TOWN OF CARMEL
ENVIRONMENTAL CONSERVATION BOARD

ENVIRONMENTAL CONSERVATION BOARD AGENDA

DECEMBER 21, 2023 – 7:30 P.M.

Re: **Request for Wetland Permit**
Brown Residence
18 Frederick Street
Mahopac, NY 10541

RAINGARDEN PLANTING PLAN

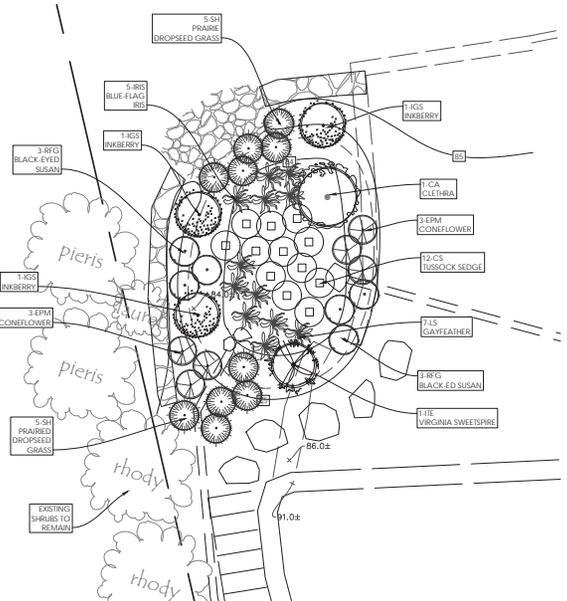
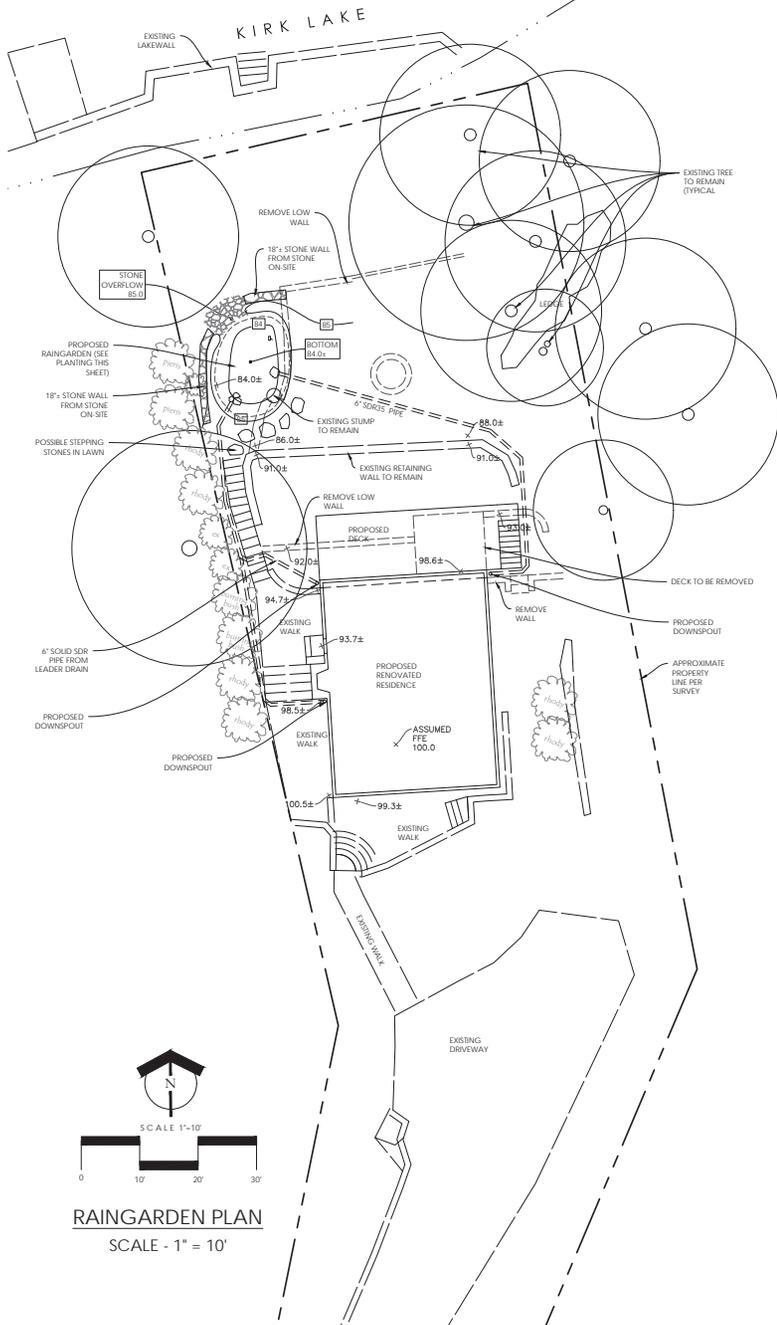
The Raingarden Plan locates the raingarden in an area below the existing retaining wall and designates the native species of plants to be planted. The raingarden has been designed to capture the water from the roof of the new second floor, which will be carried from the leaders underground in solid pipe.

SITE PLAN

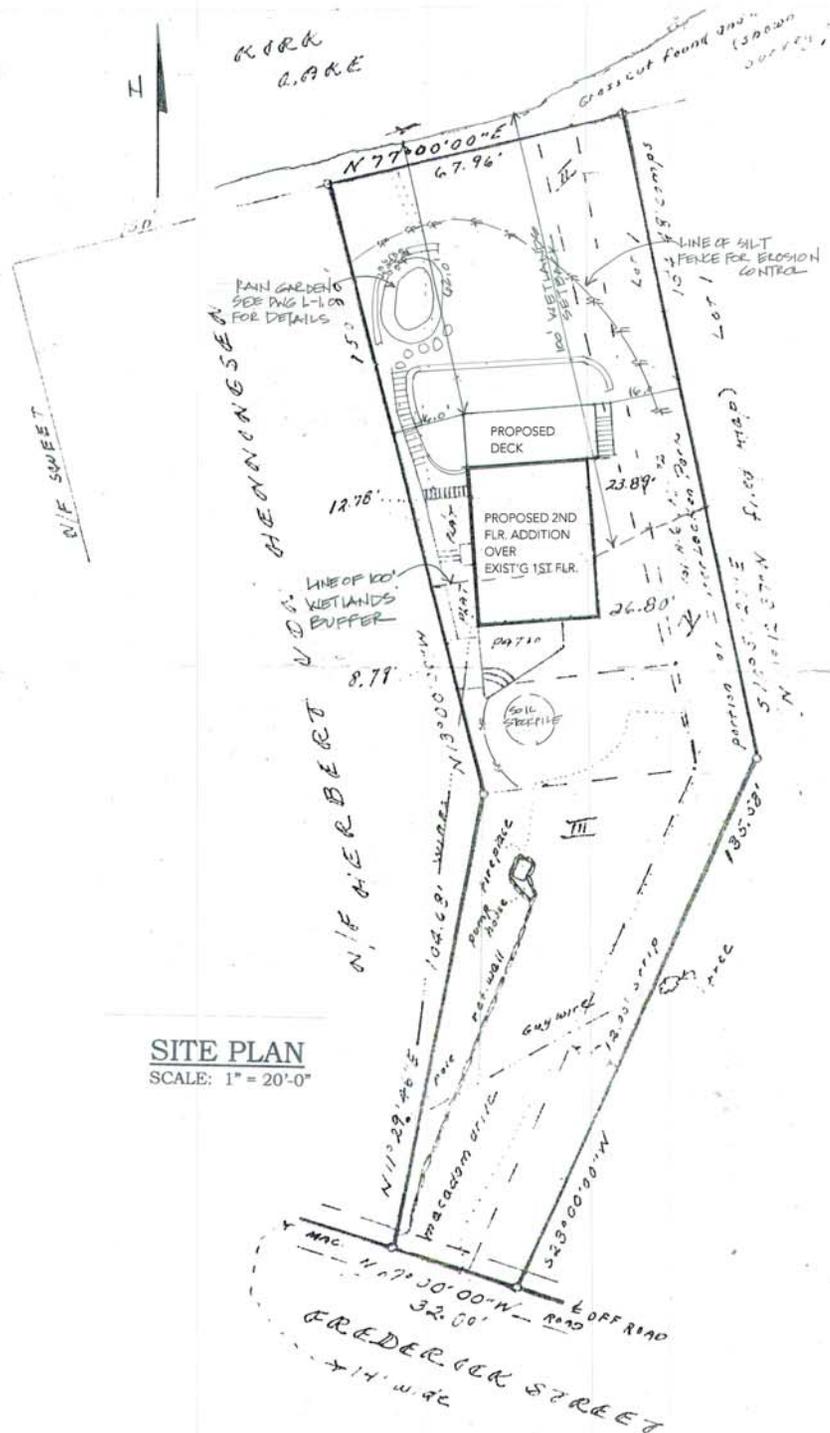
The Site Plan has the additional notes requested at the December 7th meeting of the Environmental Conservation Board. Those include:

- The silt fence inspection is to be called for from the engineering department at the beginning and again at the end of the project.
- No fueling in the wetlands buffer.
- No overnight parking in the wetlands buffer.
- Concrete mixing to be done outside the wetlands buffer.
- A designated soil stockpile area.
- A spill kit to be kept on site throughout the project.
